Fuel Pipe – Rattle –  
Install Pipe Clip

MODEL 1995 MY  
Sedan (4.0l) Range  
VIN  
720001 - 738089

ILLUSTRATION 1

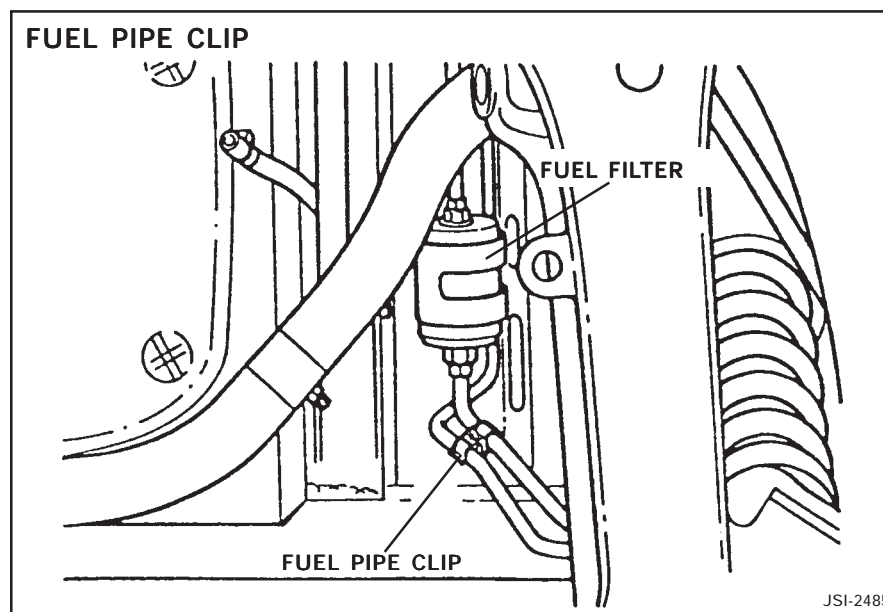
1995 MY Sedan Range vehicles within the VIN range above may experience a light rattle from the rear. The rattle occurs at idle with the vehicle stopped. A plastic fuel pipe clip was installed in production at VIN 738090 to stabilize the fuel pipes and prevent the possibility of a rattle.

1. Check the alignment of the fuel feed and return pipes near the fuel filter. The fuel pipes must not come into contact with any body member or adjacent pipes.
2. Install a plastic pipe clip (part number KDG 108104) between the fuel pipes as shown in Illustration 1.
